UNITED STATES PATENT AND TRADEMARK OFFICE

APPLICATION NO.	FILING DATE	FIRST NAMED INVENTOR	ATTORNEY DOCKET NO.	CONFIRMATION NO.
10/617,628	07/10/2003	Alexander Serkh	T02-061A	4258
26683	7590	03/23/2007	EXAMINER	
THE GATES CORPORATION IP LAW DEPT. 10-A3 1551 WEWATTA STREET DENVER, CO 80202			CHARLES, MARCUS	
			ART UNIT	PAPER NUMBER
			3682	
SHORTENED STATUTORY PERIOD OF RESPONSE		MAIL DATE	DELIVERY MODE	
3 MONTHS		03/23/2007	PAPER

Office Action Summary	Application No.	Applicant(s)
	10/617,628	SERKH ET AL.
	Examiner Marcus Charles	Art Unit 3682

DETAILED ACTION

Fig. 1

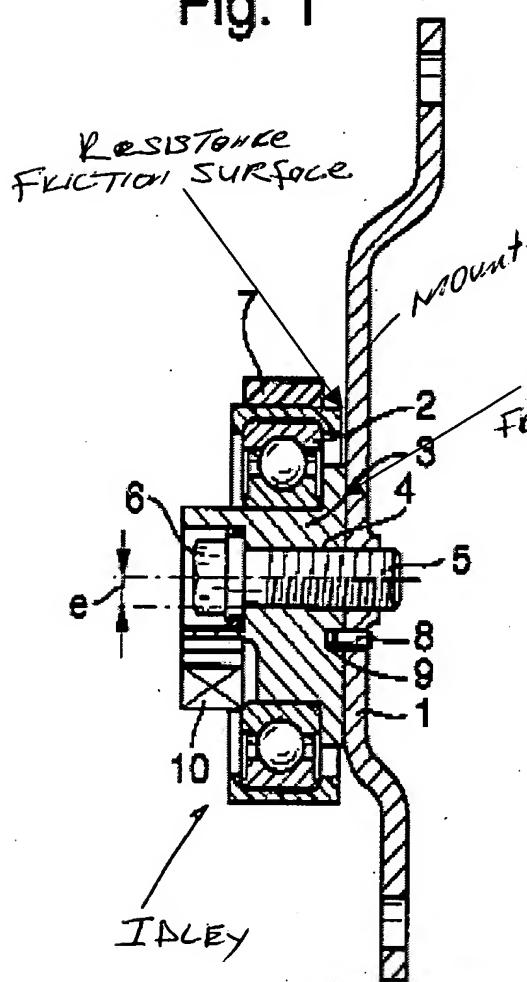
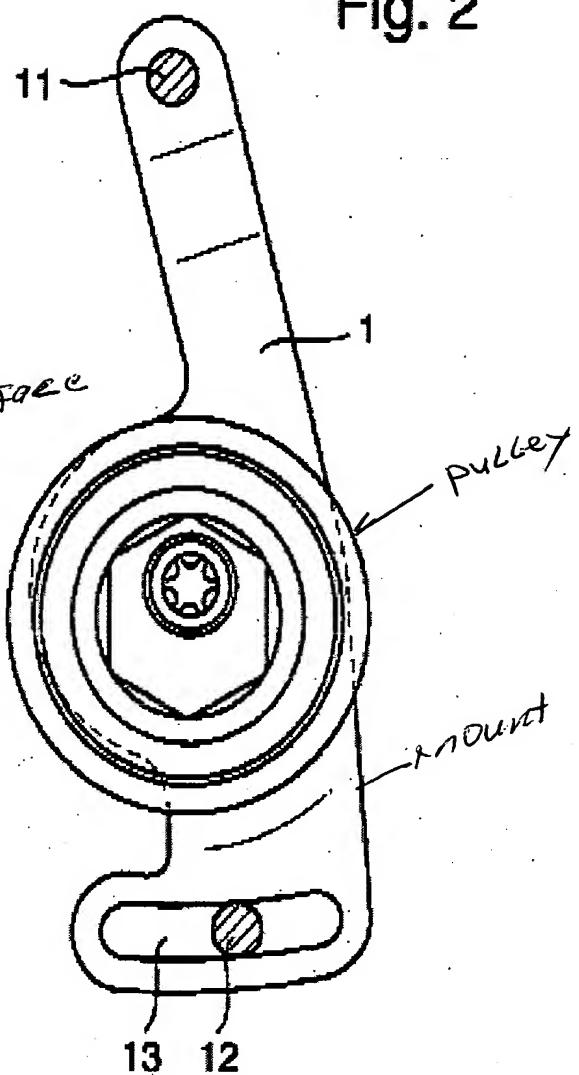
5. Claims 1-13 are rejected under 35 U.S.C. 102(b) as being anticipated by Bruchner et al. (5,820,503). Bruchner et al. discloses an idler comprising a pulley supported by a bearing (2) mount on a bearing mount which is mounted on a tension adjusted member (3, bearing mount), wherein the tension-adjusting member is in communication with a fastener (5/6) that fixes the idler to a mount (1). It is apparent that as the fastener (5/6) fixes the idler to the mount, the bearing mount (3) will actually rotate in the direction of the turning action of the fastener due to frictional torque between the contact surfaces of the fastener and the bearing mount thereby inherently tensioning on the belt.

In claim 2, note the tension adjusting member is a cylinder that cooperates with the inner portion of the bearing (2), and an eccentric bore axially therethrough.

In claim 3, note the tension adjuster comprises a reaction friction surface and a resistance surface (see attached drawing). In addition, it would be inherent for the idler

In claim 4, note the reaction resistance surface with a reaction-mating surface of the fastener and the resistance friction with the mounting surface.

Regarding claim 5, note the arm (1) having a pulley mounting portion and a dual fastener bore at (11) at one end.

In claim 6, note the curve slot (9) in the cylindrical portion of the tension-adjusting member.
